# Rezoning Transportation Analysis

Petition Number: 2019-174

**From:** Felix Obregon, PE  
[fobregon@charlottenc.gov](mailto:fobregon@charlottenc.gov)  
704-432-5729

1. **Curbline** The proposed zoning district has a setback measured from back of the existing or proposed future curbline.

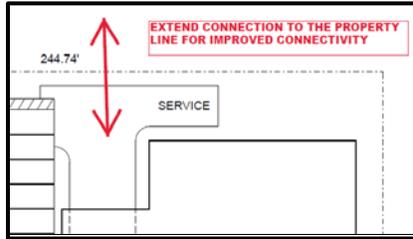
a. **Colsgate Road:** The future location of curb and gutter is in its existing location.

The site plan should show the curb and gutter labeled and dimensioned from the centerline for each road.

**Technical Correction based on site plan 02/10/2020:** Petitioner is showing dimension from C/L to what appears to be edge of pavement, please updated to dimension existing back of curb.
